Addendum to Environmental Impact Assessment Report

For Development at Ardarostig, Bishopstown, Cork.
on behalf of Bridgewater Homes Ltd.

Client	Bridgewater Homes Ltd	
Project Title	Ardarostig LRD	
Document Title	Addendum to Environmental Impact Assessment Report	
Document Comprises	Volumes	--
	Pages (Including Cover)	18
	Appendices	3
Prepared by	Ciaran Dineen	
Checked by	Andrea McAuliffe	
Office of Issue	Cork	
Document Information	Revision	A
	Status	Submitted
	Issue Date	November 2025
	CORK 6 Joyce House Barrack Square Ballincollig Cork P31 YX97	DUBLIN Kreston House Arran Court Arran Quay Dublin 7 D07 K271
www.mhplanning.ie	T. +353 (0)21 420 8710	T. +353 (0)1 804 4477

This Addendum has been completed to address the further information requested issued by Cork City Council on the 29th October 2025.

"Figure 1 - Dwg. No. 23161/P/003 by Deady Gahan Architects – Layout submitted for RFI response."

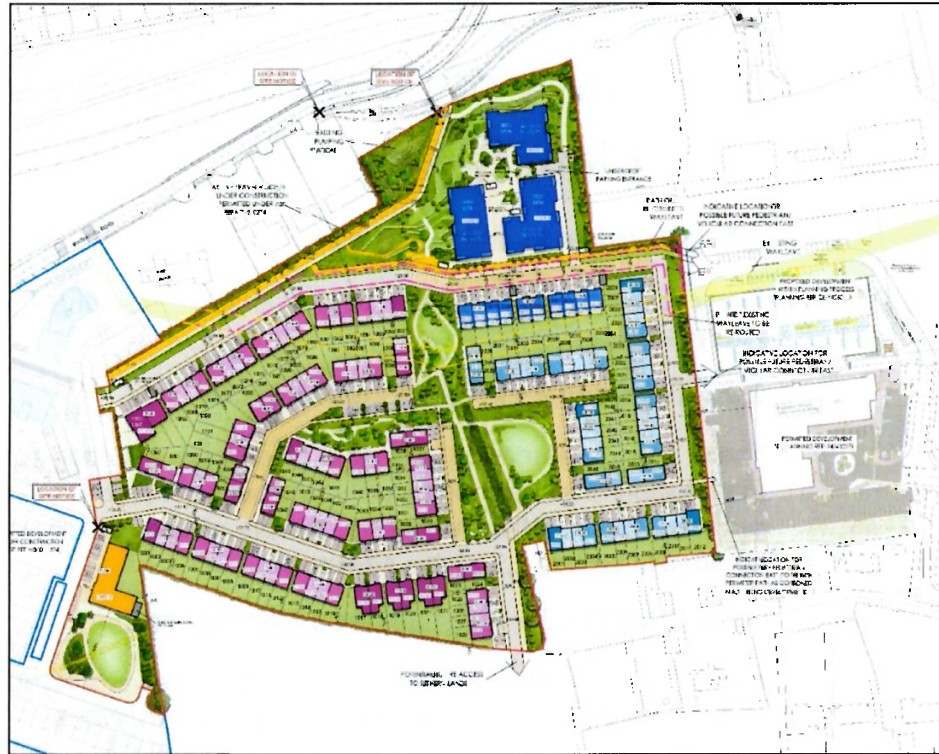
The layout proposes 246 no. units with a density of 51.3 units/ha which remains unchanged from the previous proposal. Usable open space measures 15%.

The landscape has been amended to the north of Block 1 to allow the 2 no. apartments on the lower ground floor to have direct access onto a semi-private amenity space. The tiered landscaped area has also been revised to provide a higher quality open space for the apartments to utilise and is now coordinated with the new location of the attenuation tank. The tank is now located fully within the Taken in Charge area and is easily accessible for maintenance.

A low retaining wall has also been added to the central open space linked to character area 3 to accommodate an updated attenuation tank form."
